CALIFORNIA COASTAL COMMISSION

F13a

To: Commissioners and Interested Persons
From: Dan Carl, Central Coast District Director
Mike Watson, Central Coast District Coastal Planner
Subject: **STAFF REPORT ADDENDUM for F13a**
Application A-3-SNC-98-114-EDD (SNG Dispute Resolution Hearing)

3 Additional Signs at Resort Roundabout

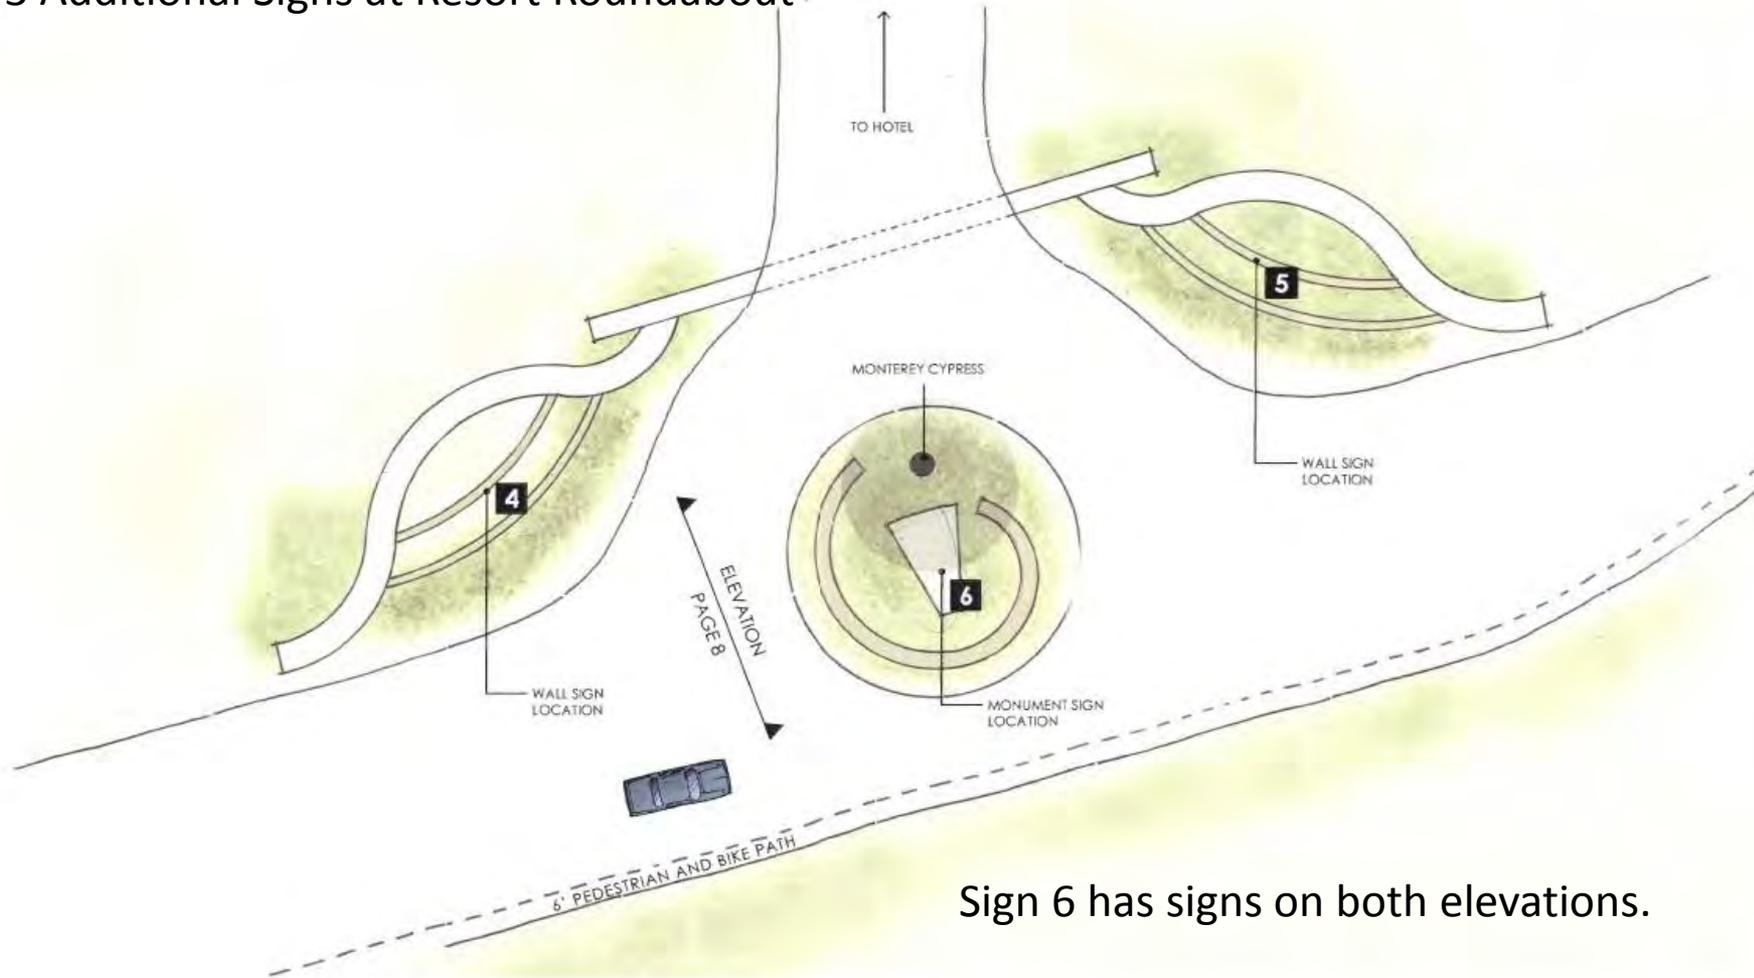
Staff has repeatedly commented on the issue of resort signage commencing with Staff's comments on the originally submitted sign plans in July 31, 2014. As noted then, the submittal did not contain the necessary documentation or detail to fully assess various project elements for consistency with the conditions on the permit. SNG claims that Staff has mischaracterized the size of each of the resort entry signs. Although SNG has asserted in letters that the signs are smaller than Staff believes (see SNG March 9, 2015 letter and May 8, 2015 letter), these signs are shown on the plan detail sheets (see Exhibit 1). The sheets depict large monolithic concrete walls and/or sign backing with lettering inset and/or placed on the face of the structures. There are seven Monterey Bay Shores resort signs depicted between the entry and the hotel access tunnel – a distance of about 400 hundred feet. These signs, which include the sign-backing structure and lettering, are shown on the project plans as follows: 1) 15' x 40' at the toe of the large dune; 2) two signs 10' x 13' in size at the resort entrance; 3) two signs 5' x 30' on either side of the hotel tunnel entrance, and surrounded by what appears to be significant concrete wrap-around elements; and 4) a wedge-shaped sign 9' x 10' with two aspects set atop of monument-style pedestal (see Exhibit 1).

Sign 6 has signs on both elevations.

October 2013 Lighting Plan

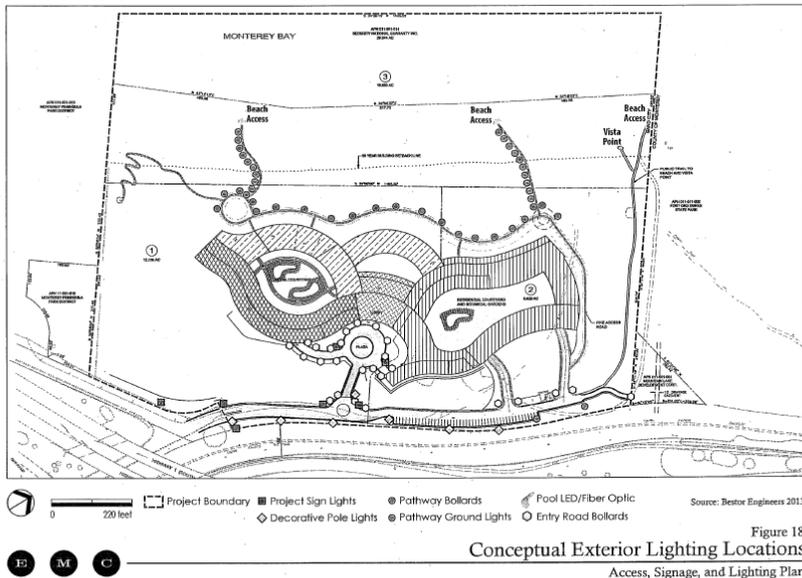
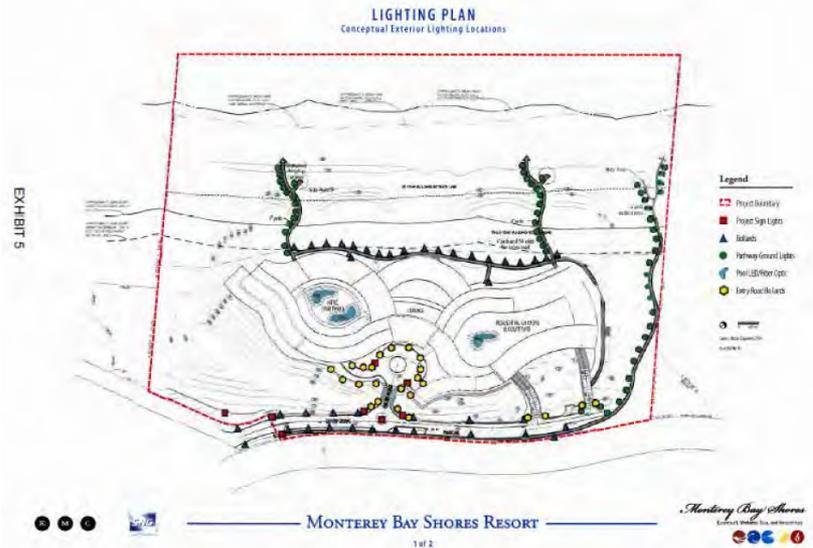
Few bollards. No access path lighting.

Expanded road and access path lighting.

PUBLIC ACCESS MANAGEMENT PLAN Resort Coastal Access

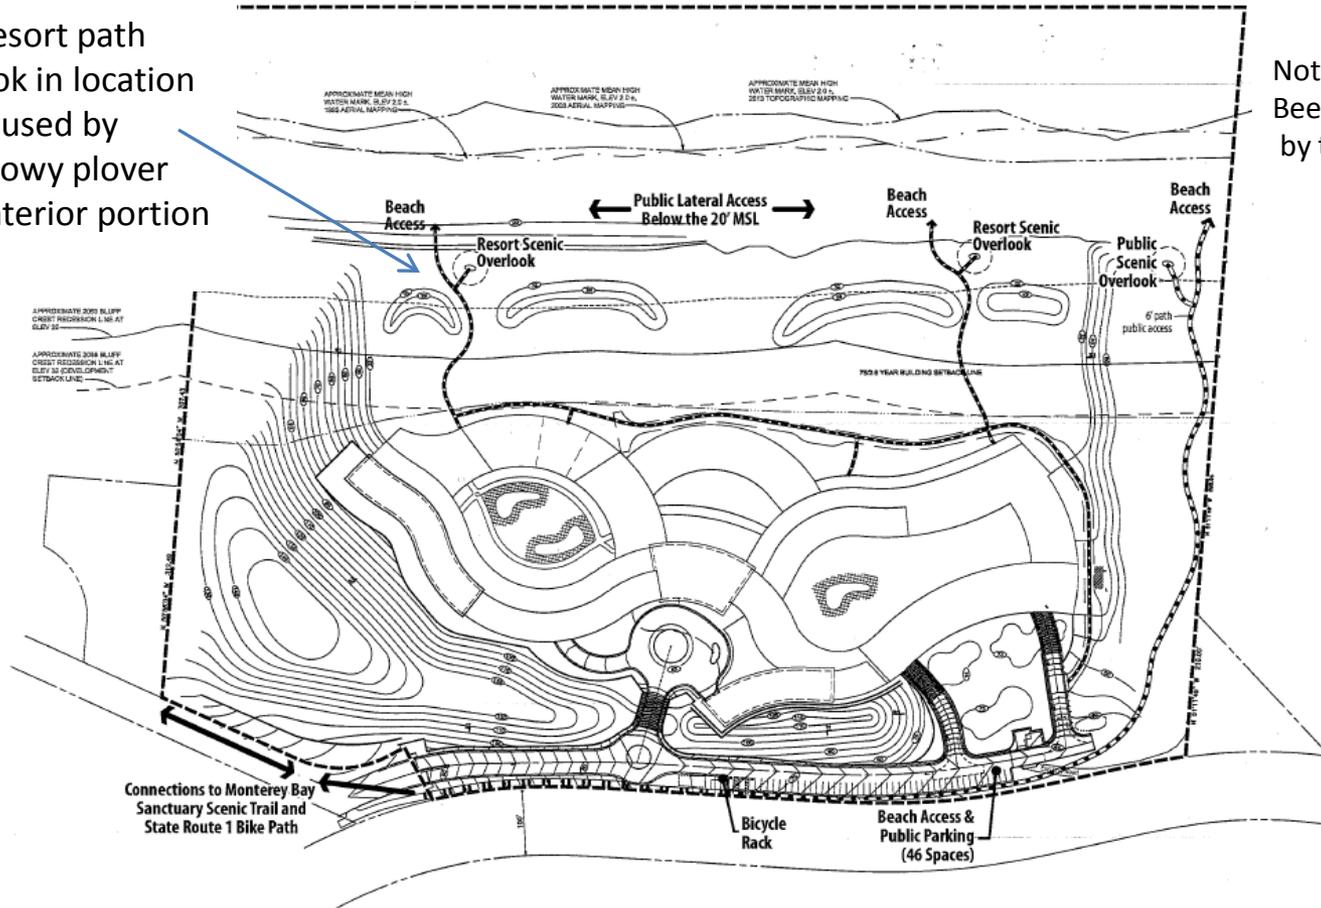
Southern resort path and overlook in location historically used by Western snowy plover to access interior portion of site.

Note: dune depressions have been removed from the project by the applicant.

LEVEL +122 ROOF PLAN
CONCEPTUAL FLOOR PLANS
Monterey Bay Shores Resort

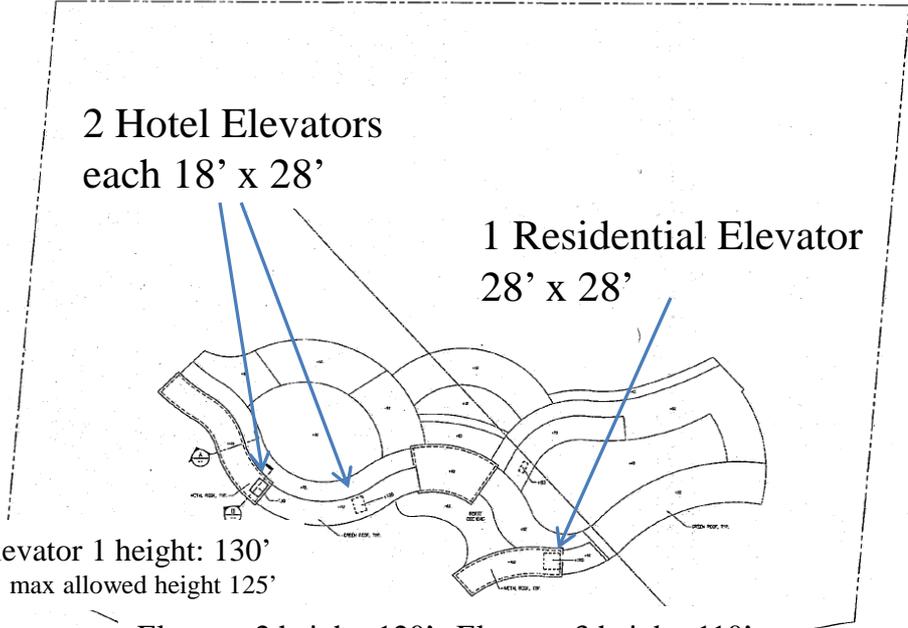
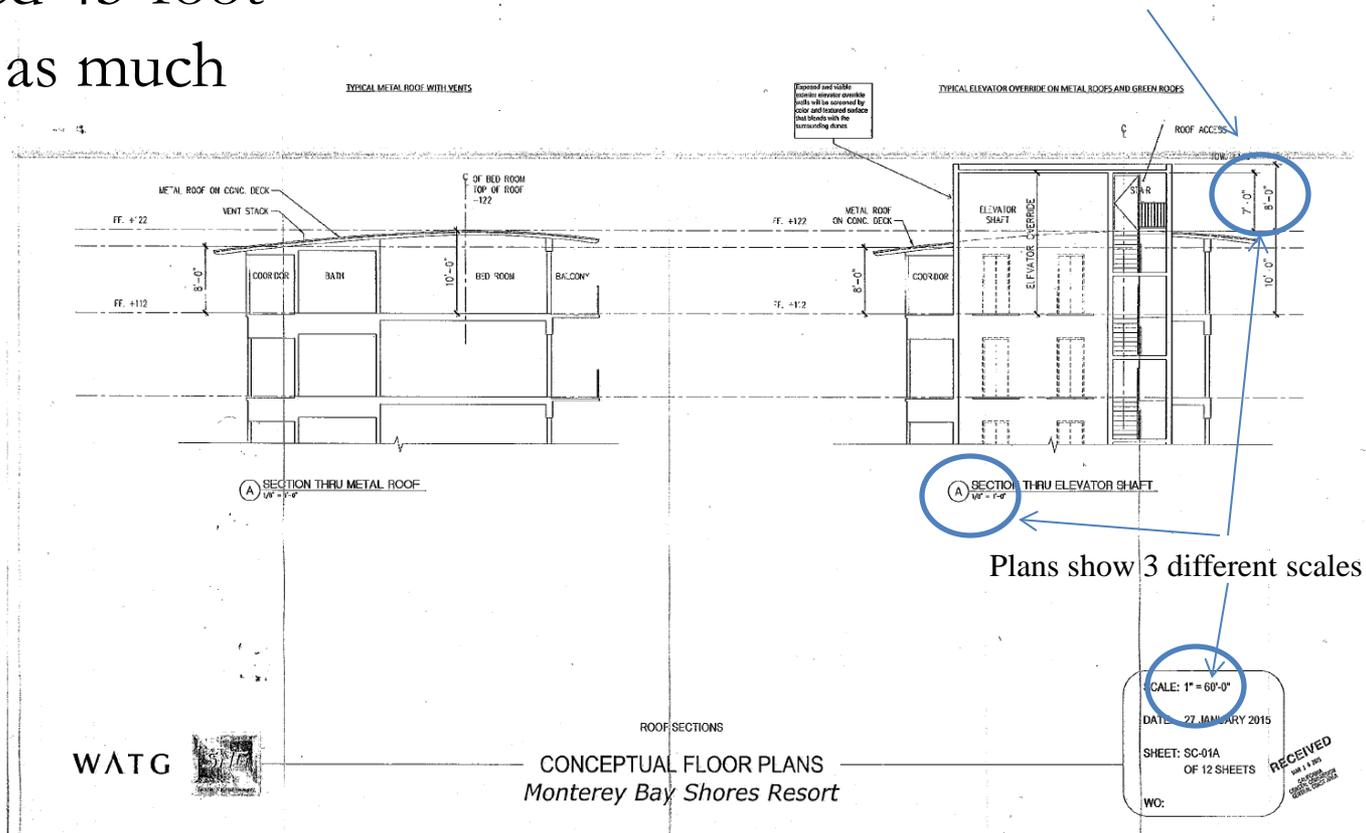
The Applicant suggests that this issue applies only to one elevator override, but the plans depict two. The Applicant's submitted plans also have several scales, so they are difficult to analyze, but they depict these structures as a minimum of 18' x 28' (SNG asserts that they are 12' x 24', but its plans show otherwise).³ See Exhibit 5. Staff compared the rooftop plans with the Height Conformance plan sheet submitted in October 2014 to conclude that both hotel overrides exceed the 45-foot height limit imposed by Special Condition 1(e).⁴ By its terms, Special Condition 1(e) applies to all development.

³ Sheet FP-11 of 12 has a general scale in the legend of 1" = 60', a plan detail scale of 1" = 8', and actual measurements indicating a scale of 1" = 4'. Staff used the lesser of these scales (1" = 4') to estimate the size of the elevator overrides and rooftop stairway as shown on FP-11.

Elevator Overrides Height and Size

2 Hotel Elevators
each 18' x 28'

Plans show 3 different scales

Cross-Section DV-3

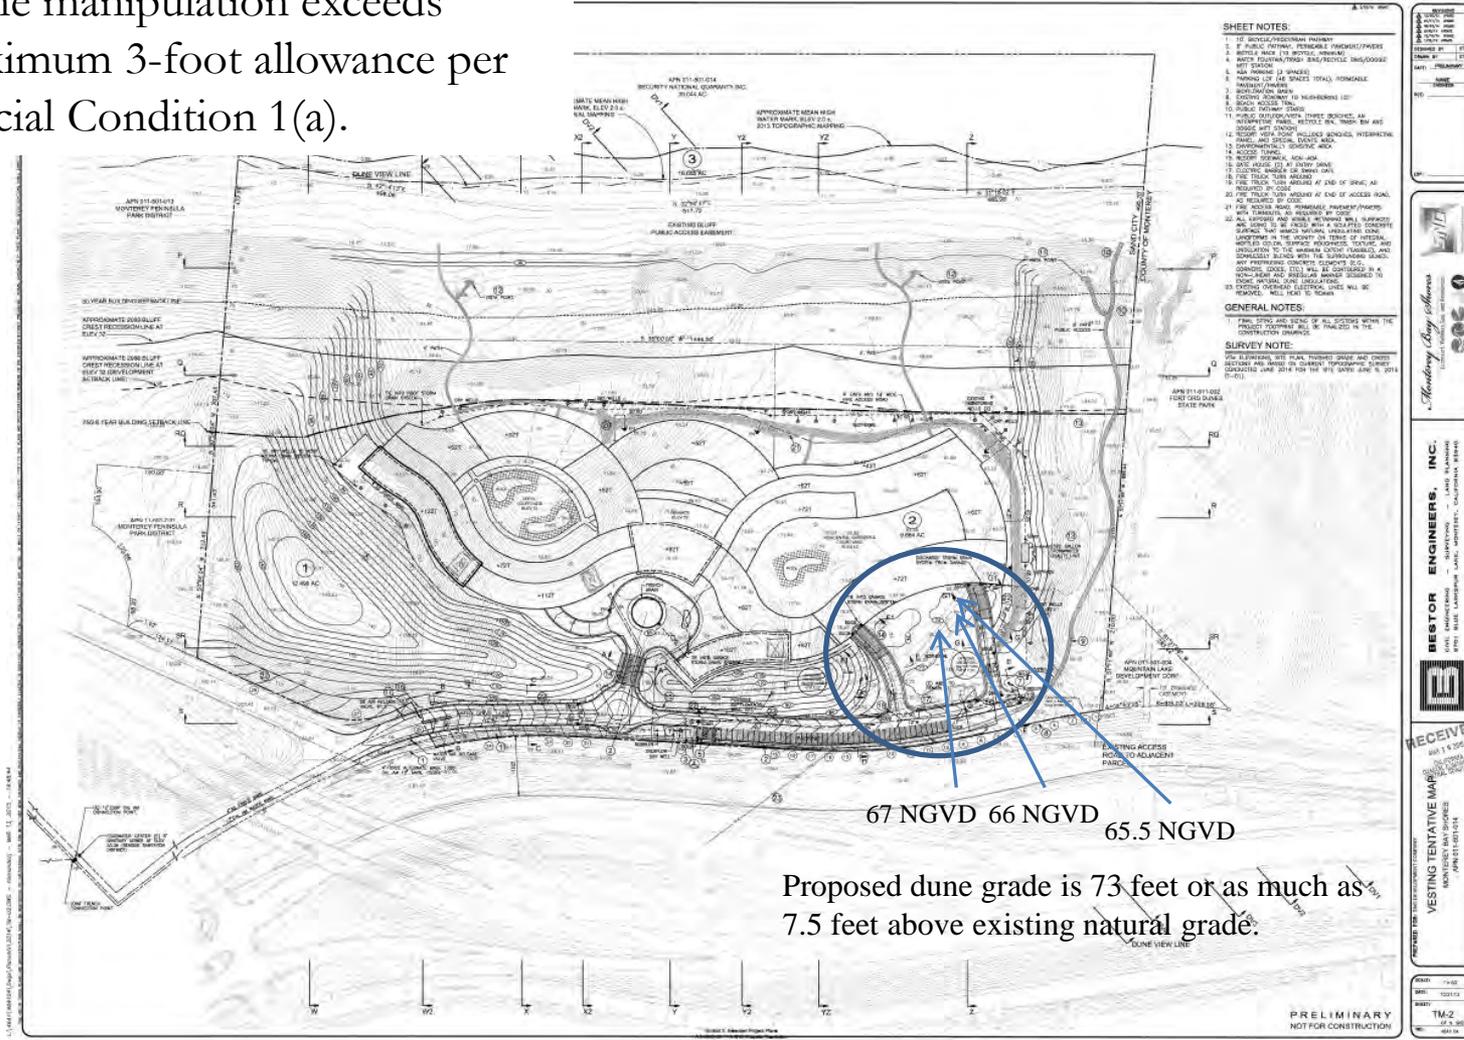
Dune manipulation exceeds maximum 3-foot allowance per Special Condition 1(a).

understand the relationship between the two without the requested elevation. For now, though, we need three things on this point: first, for any grade shown to be above existing grade, it must be lowered to no more than 3 feet above existing grade (e.g., plan sheets TM-2, TM-4, TM-5, and TM-6 show some instances where the grade is more than 3 feet above existing); second, any areas where the grade exceeds existing must be limited to discrete undulation areas that are sited to help make the dunes appear as natural as possible and to provide for dune landscaping and screening; and third, for any grades greater than existing grade (but, again, no more than 3 feet above that), we need evidence of the manner in which such additional grade is necessary to allow for undulations for dune landscaping in that area. Please correct all applicable plan sheets and submit revised plan sheets to address these points.

Cross Section DV-2

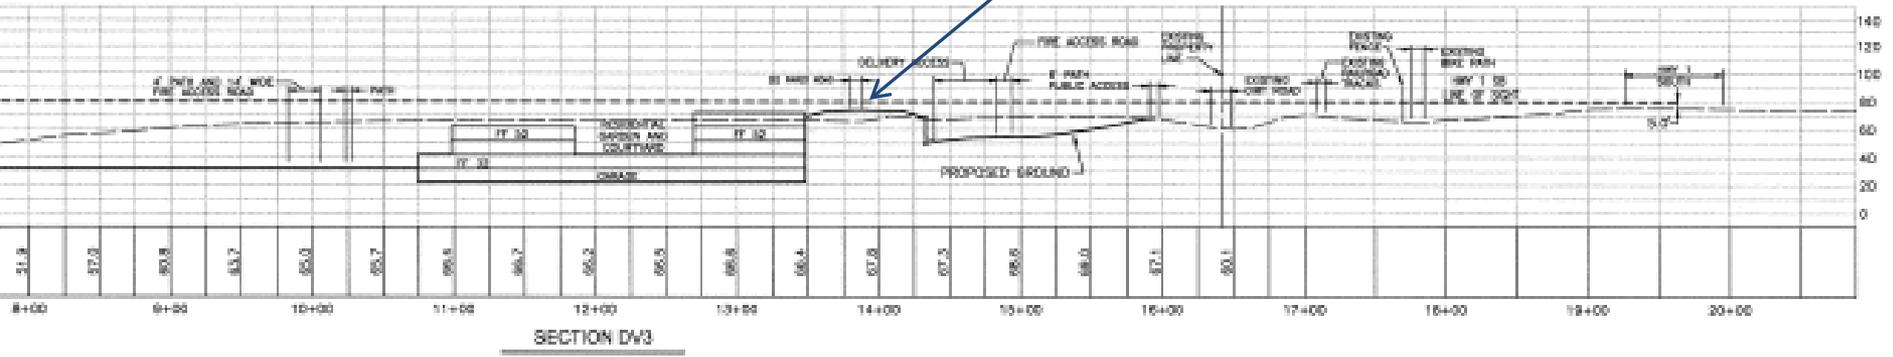
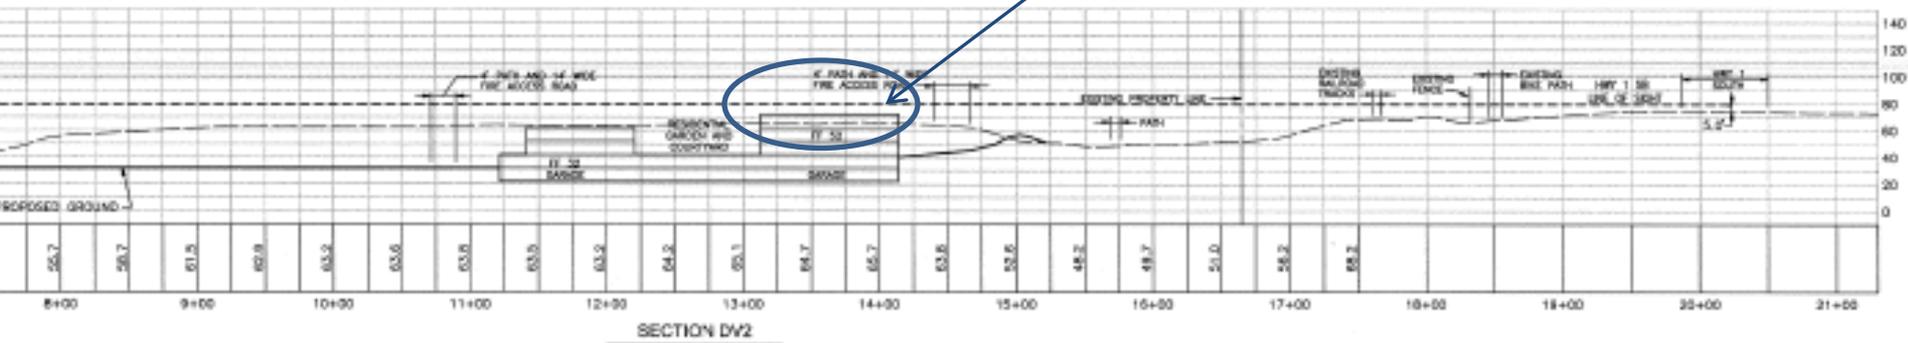
First, the only thing allowed above existing grade is manipulated dune, and not buildings. SNG's proposed buildings exceed existing grades in this area, in places as much as 7 feet above existing grade as shown on their plans (see Exhibit 6, Page 3). This is simply not allowed, and it will result in *more* of this particular view being blocked in this protected area than is the existing case, and this is not allowed (additional view blockage is allowed in other portions of the development). Second, even the dune manipulation proposed by SNG exceeds existing grade by more than 3 feet, up to 7 feet in places (see Exhibit 6). This is also not allowed.

Dune manipulation exceeds 3-foot limit imposed by Special Condition 1(a). Building visible from southbound Highway One.

Building exceeds existing grade by 7 feet in this location.

Northbound Highway One Views

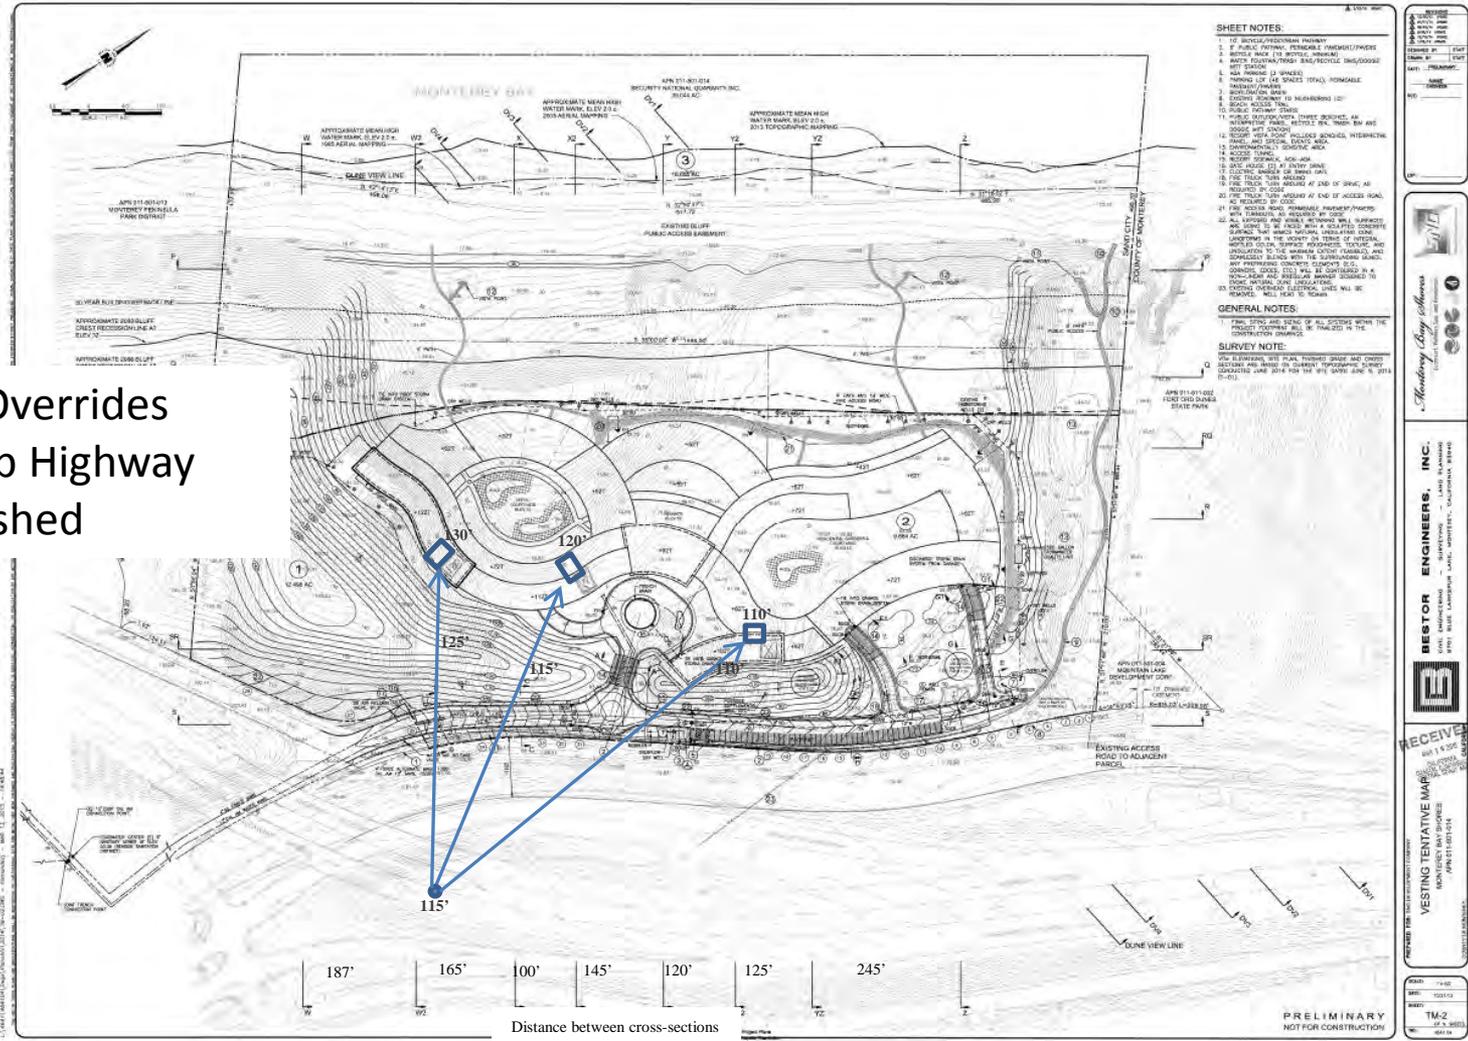
Elevator Overrides
within N/b Highway
One viewed
